TITLE OF PROJECT: Berkey Hall – Room 10 - Renovation

PROJECT NUMBER: CP25054

ADDENDUM NO: 1

This Addendum is issued prior to receipt of Proposals to amend the Contract Documents identified as Berkey Hall – Room.

M101

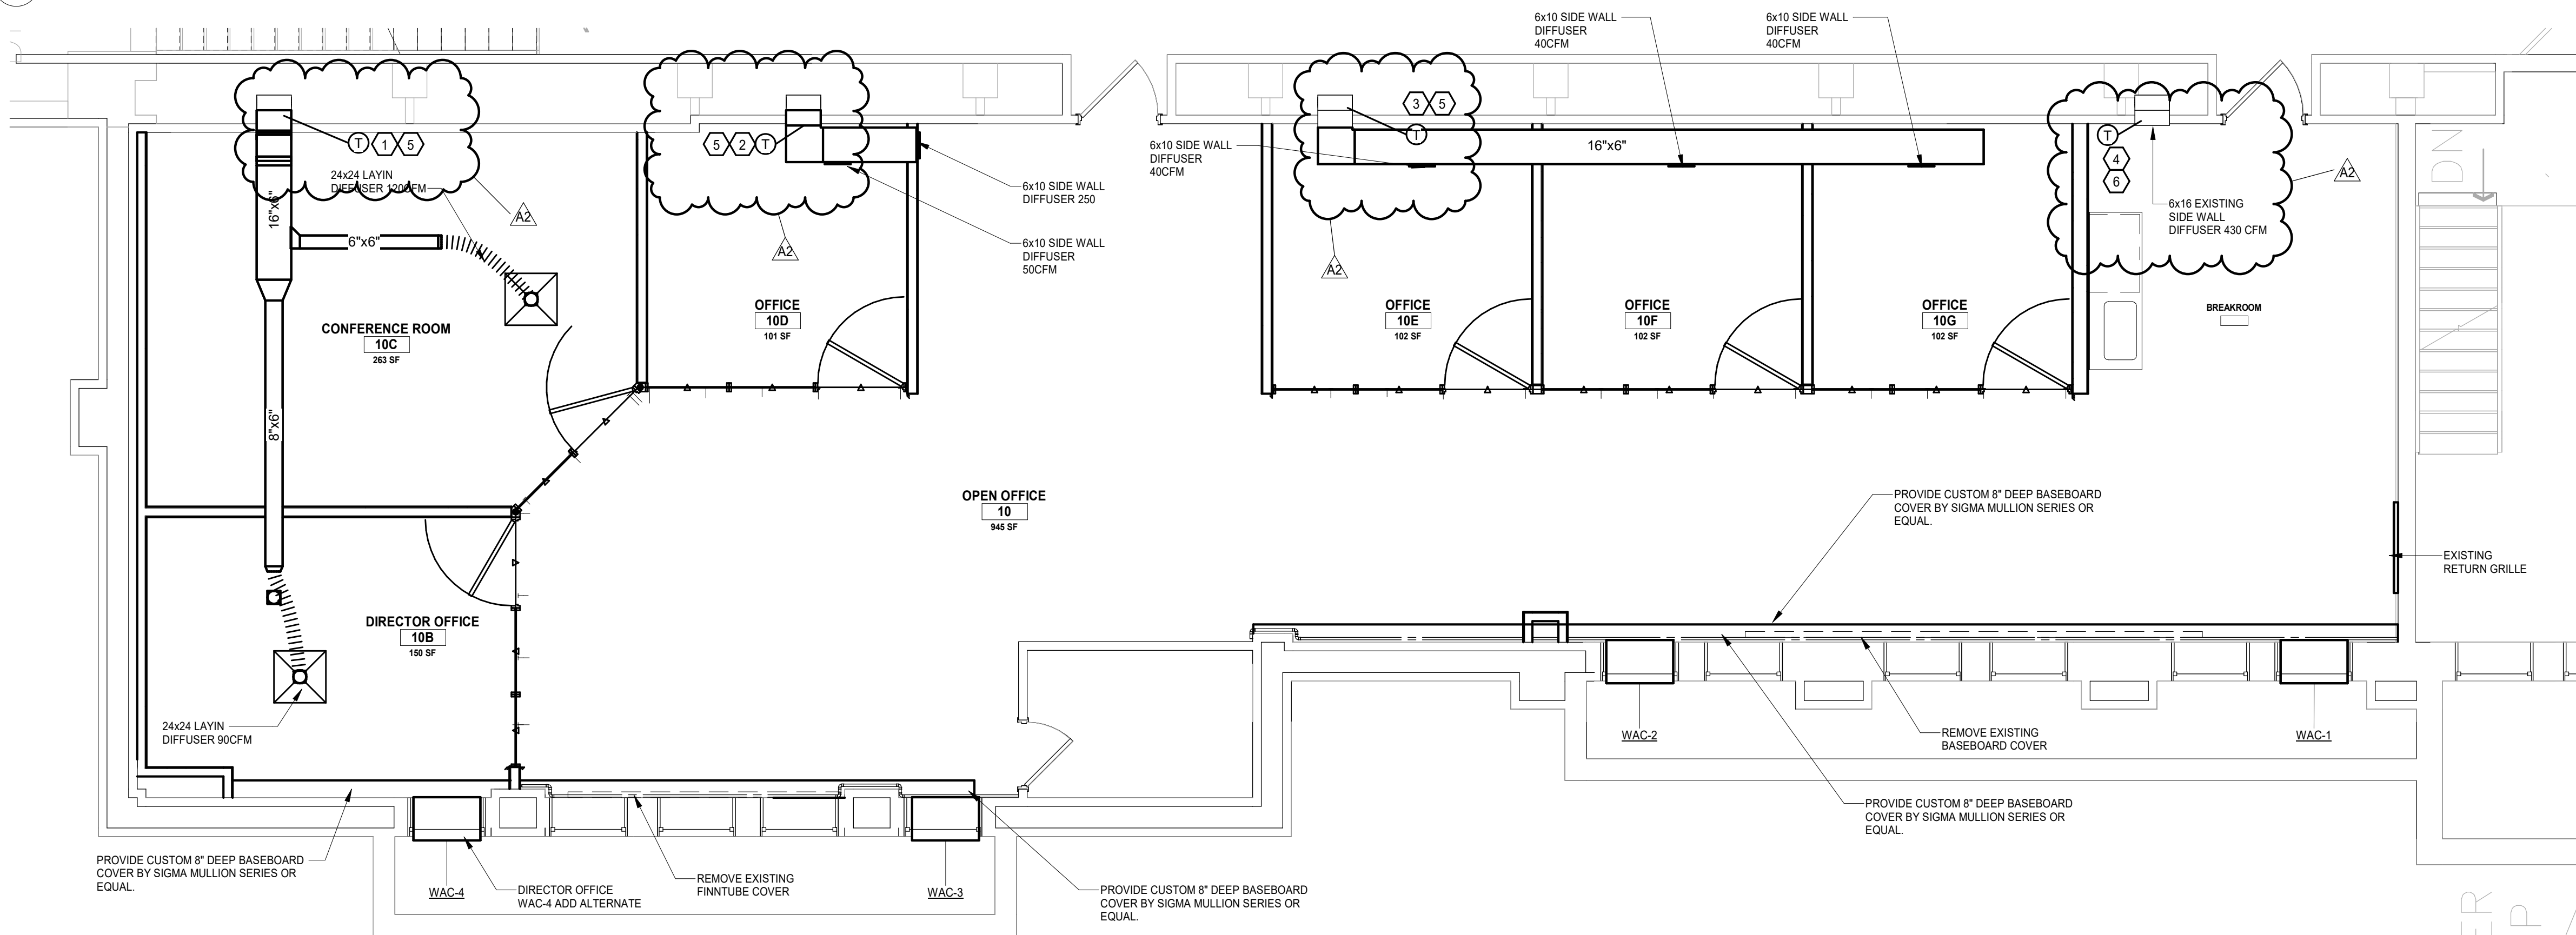
1. PROVIDE NEW DDC THERMOSTAT, REMOVE ASSOCIATED PNEUMATIC CONTROL VALVE SERVING REHEAT COIL, TAGGED 151C. REPLACE CONTROL VALVE WITH ELECTRIC CONTROL VALVE AND TIE INTO DDC SYSTEM.
2. PROVIDE NEW DDC THERMOSTAT, REMOVE ASSOCIATED PNEUMATIC CONTROL VALVE SERVING REHEAT COIL, TAGGED 195. REPLACE CONTROL VALVE WITH ELECTRIC CONTROL VALVE AND TIE INTO DDC SYSTEM.
3. PROVIDE NEW DDC THERMOSTAT, REMOVE ASSOCIATED PNEUMATIC CONTROL VALVE SERVING REHEAT COIL, TAGGED 201. REPLACE CONTROL VALVE WITH ELECTRIC CONTROL VALVE AND TIE INTO DDC SYSTEM.
4. PROVIDE NEW DDC THERMOSTAT, REMOVE ASSOCIATED PNEUMATIC CONTROL VALVE SERVING REHEAT COIL, TAGGED 213. REPLACE CONTROL VALVE WITH ELECTRIC CONTROL VALVE AND TIE INTO DDC SYSTEM.
5. PROVIDE FIRE DAMPER AT CMU WALL. PROVIDE 12X12 ACCESS PANEL IN DUCT AND SOFFIT FOR FIRE DAMPER ACCESS.
6. PROVIDE FIRE DAMPER AT CMU WALL.

**A101**

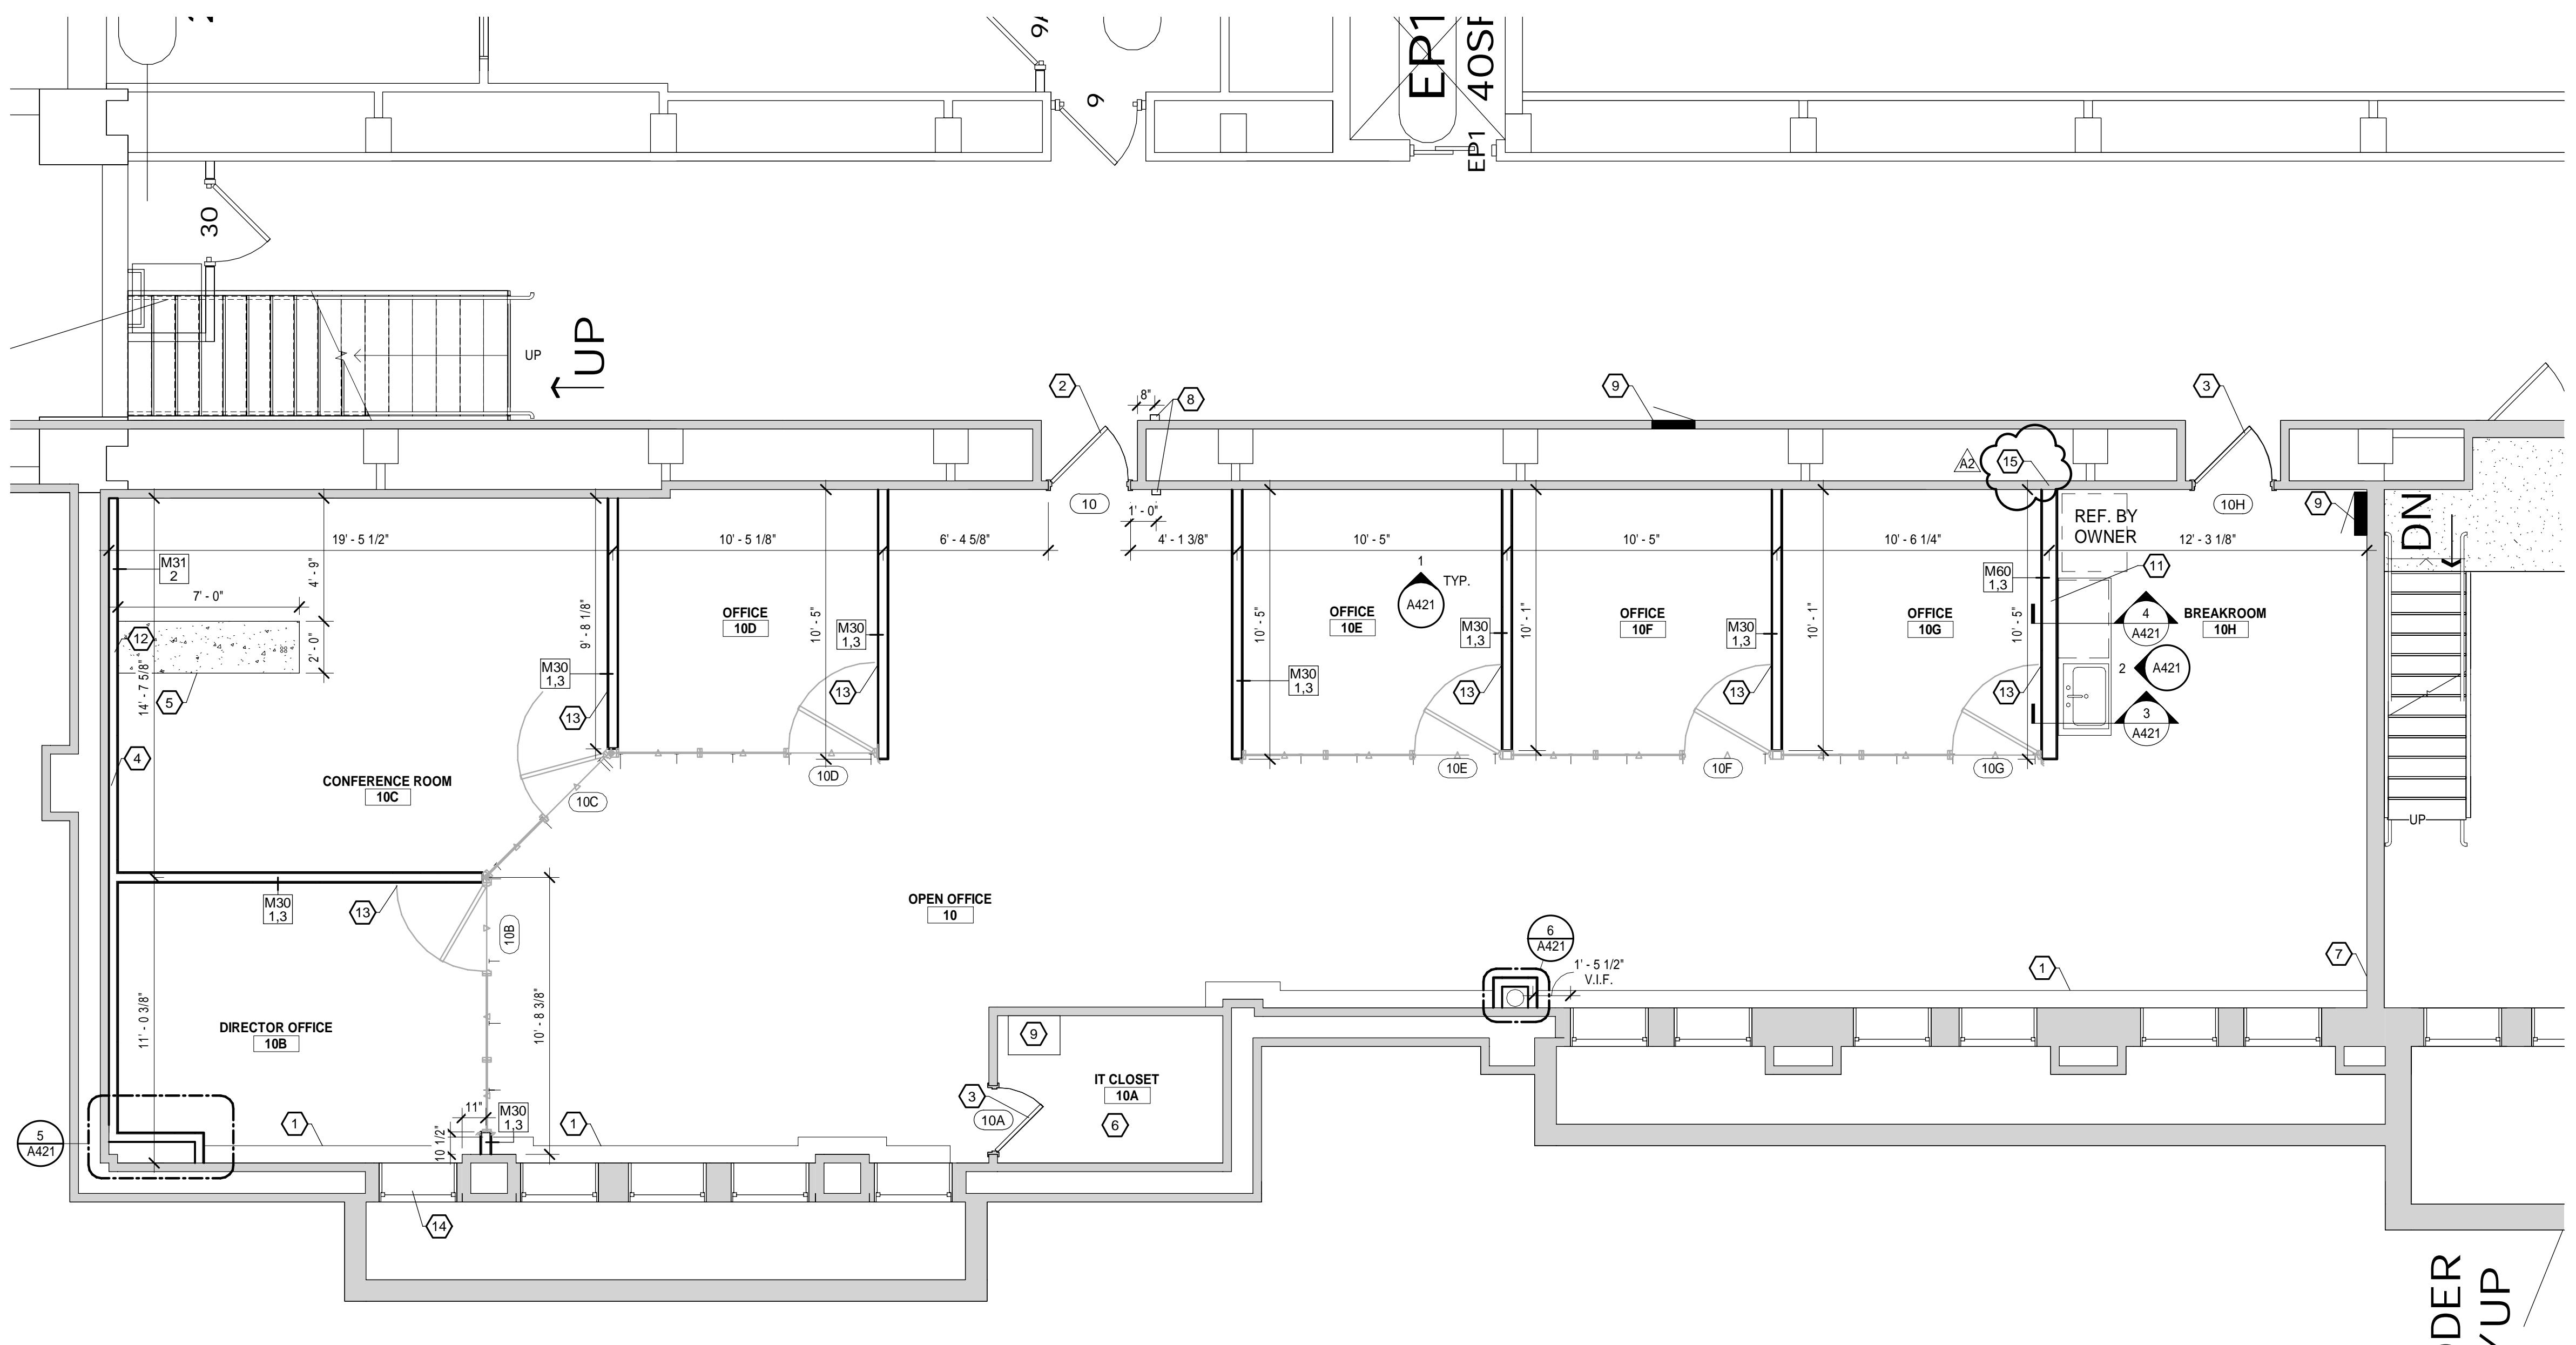
- MODIFY EXISTING WINDOW AS NEEDED FOR NEW WAC-4 UNIT. SEE MECHANICAL.
- REINSTALL REMOVED BLOCK. REPAIR AND REPLACE AS NEEDED FOR CLEAN, SMOOTH FINISH.
